FILE NO. 85-81 **DUE DATE** 9/14/81
ACTIVITY Rusty Sun Subdivision
PHASE Preliminary Plan & Annexation to PR 8.4 **ACRES** _____
LOCATION NW corner 29 Rd. & F Rd.
PETITIONER Sego Services c/o Jim Lindell
PETITIONER ADDRESS 842 25 Road, Grand Junction, CO 81501
ENGINEER Paragon Engineering, Inc.

RESPONSE TO REVIEW SHEET COMMENTS

FILE NO. 85-81 DUE DATE 1/15/82
 ACTIVITY Rusty Sun Filing #1
 PHASE Final Plan ACRES _____
 LOCATION NW corner of 29 Rd. and Patterson Rd.
 PETITIONER Sego Services c/o Jim Lindell
 PETITIONER ADDRESS 843 25 Rd., Grand Junction, CO 81501
 ENGINEER Paragon Engineering

RESPONSE TO REVIEW SHEET COMMENTS

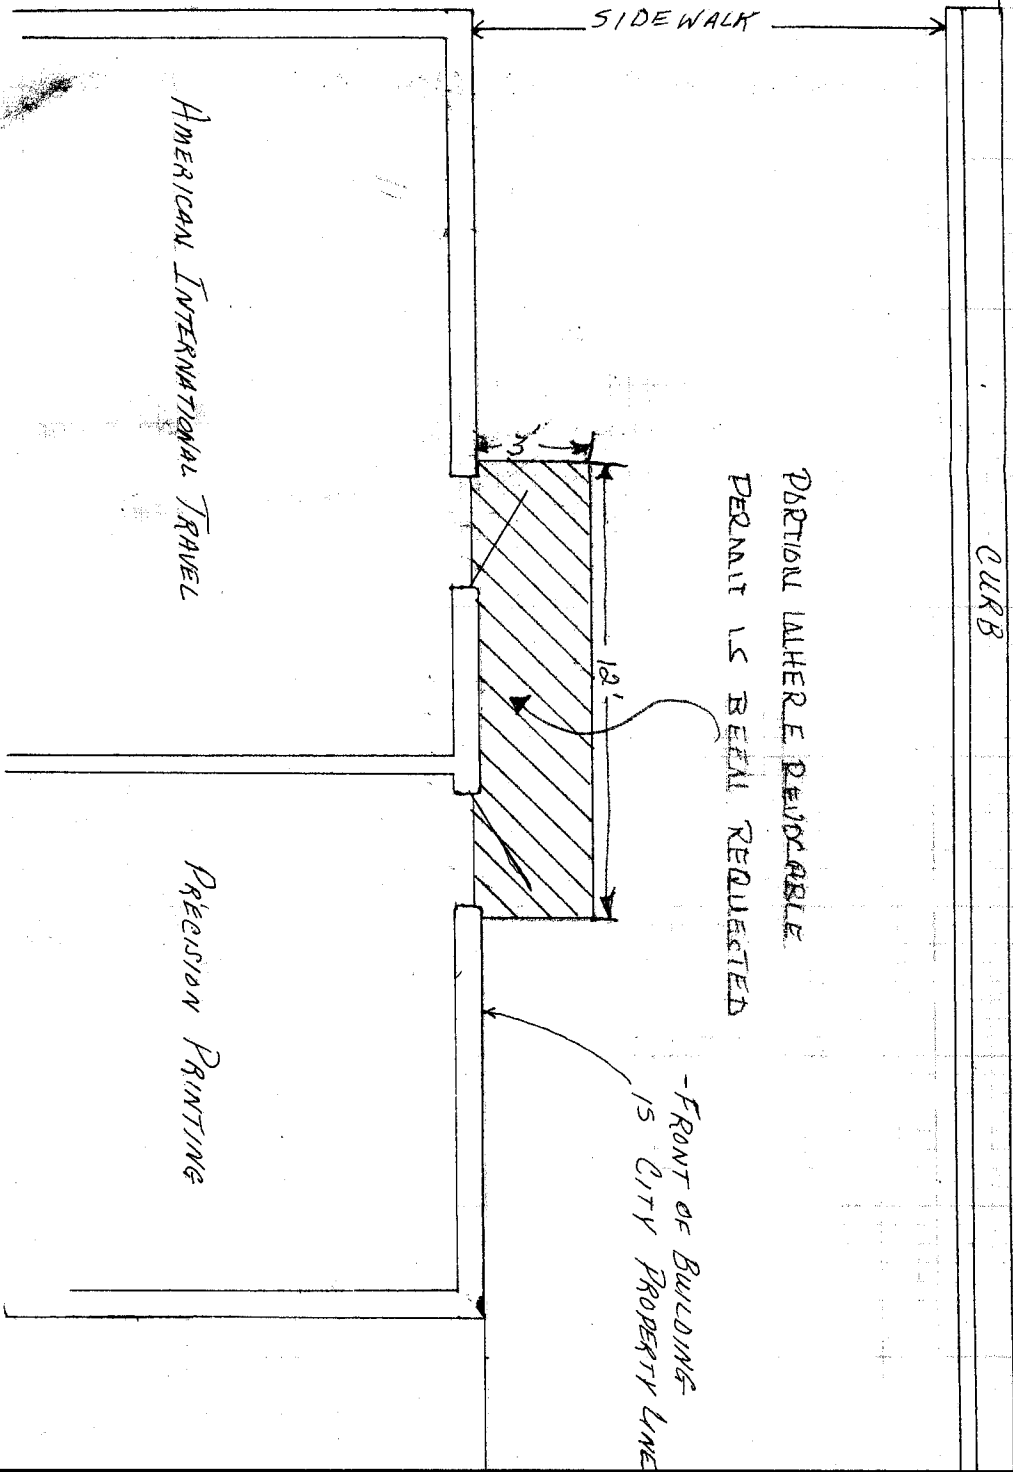
01/27/81 FRANK/SIMONETTI PASSED 5-0 A MOTION TO RECOMMEND APPROVAL TO THE CITY COUNCIL OF #1-81 REVOCABLE PERMIT FOR A STEP IN THE CITY RIGHT OF WAY AT 222 NORTH 7TH STREET, AS PRESENTED IN THE DRAWING.

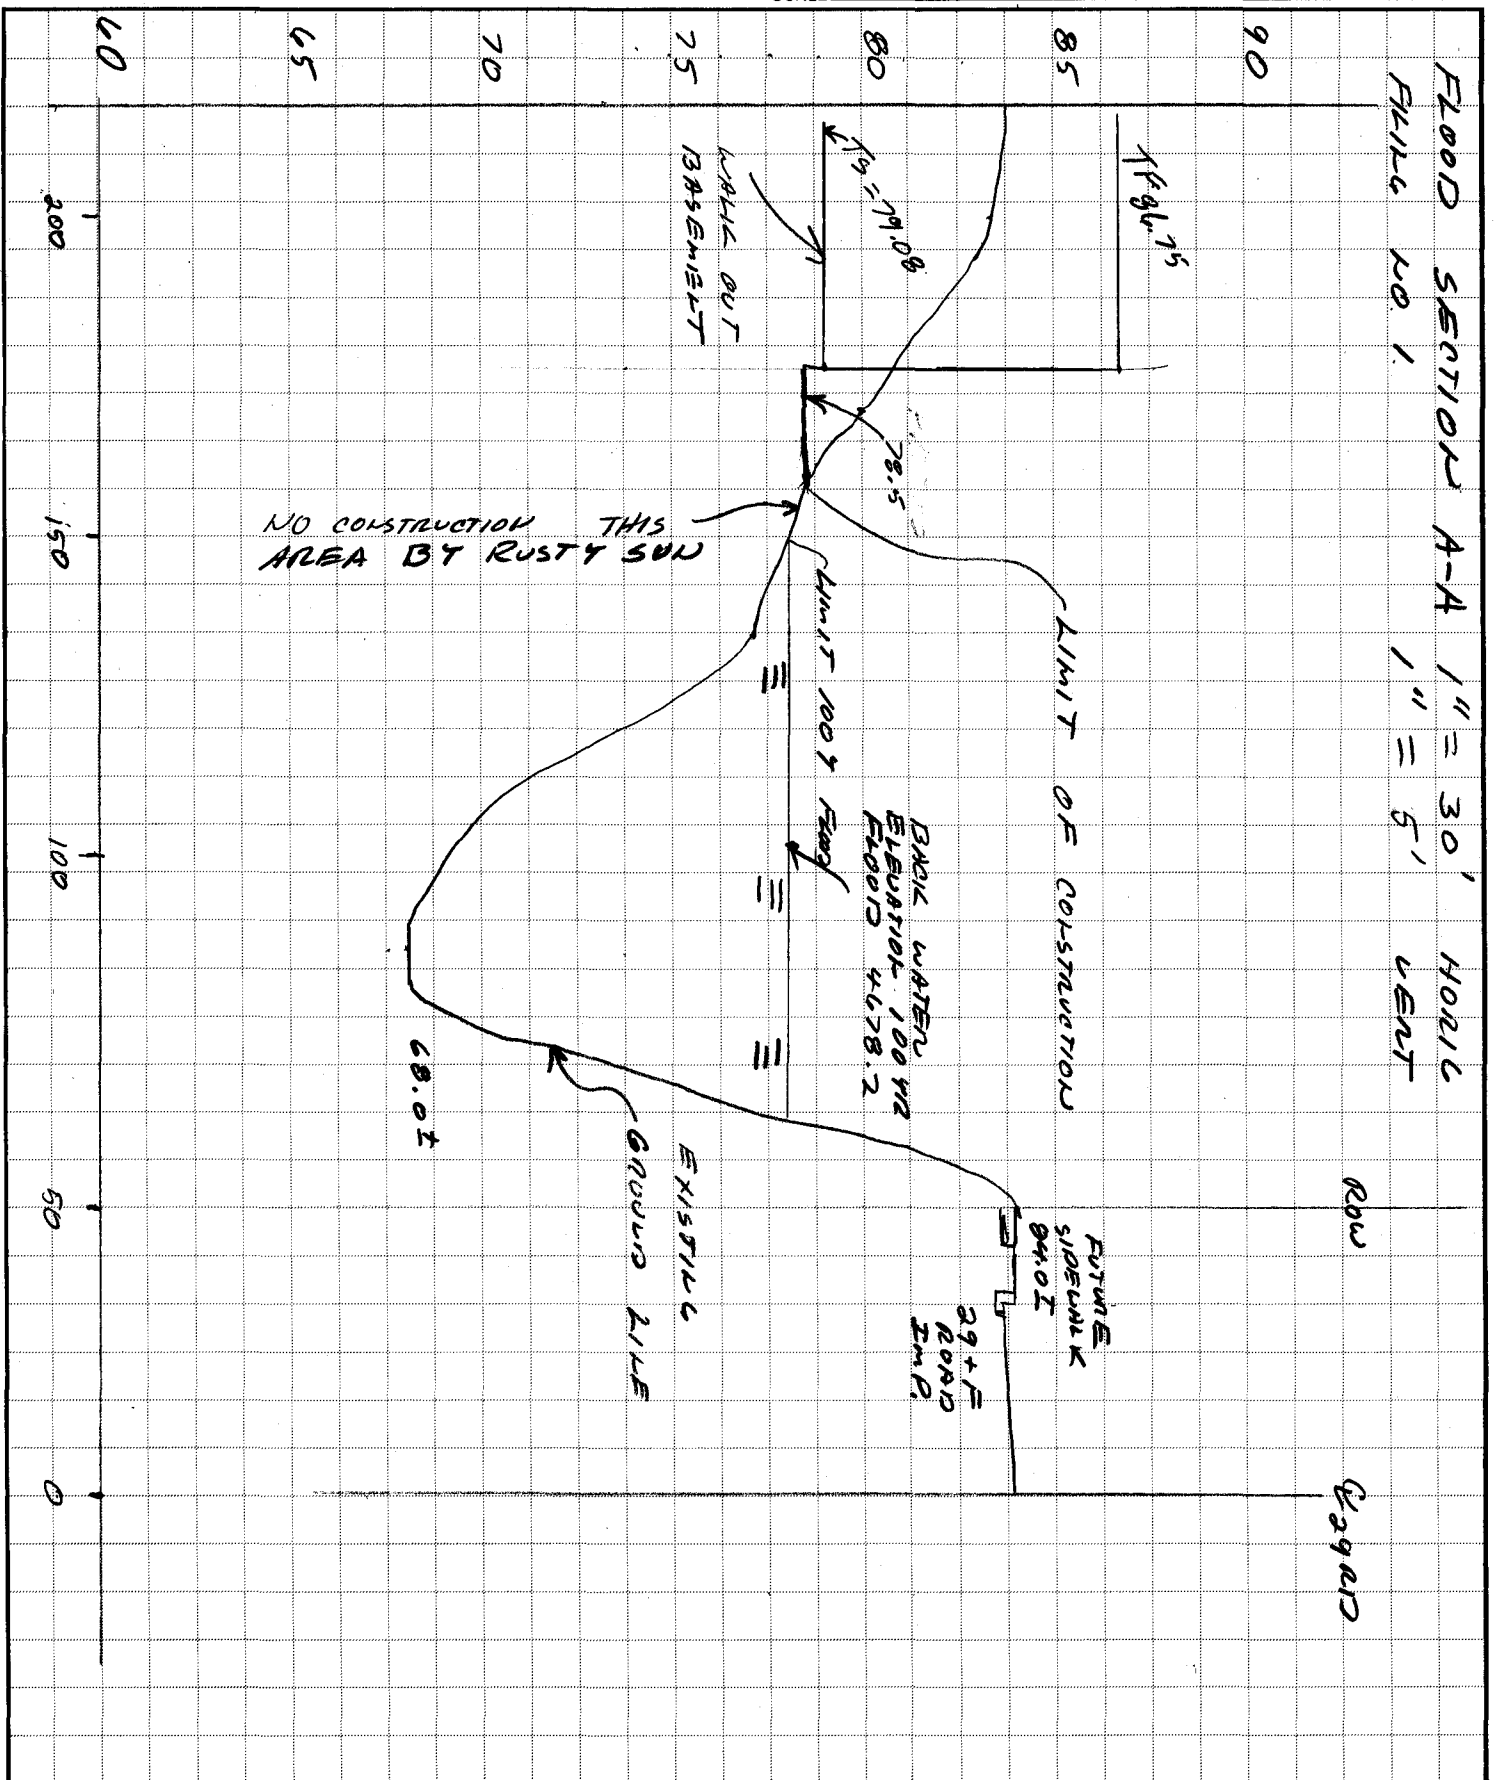
Please find enclosed a marked up blueline print of a Revised Grading plan of Rusty Sun #1 showing we will not be working within the 100 year flood plain. As we discussed, after construction is completed by the State and County on the 29 and F Road improvements, we will survey the area and determine what changes have occurred and work out appropriate measures, if any are required.
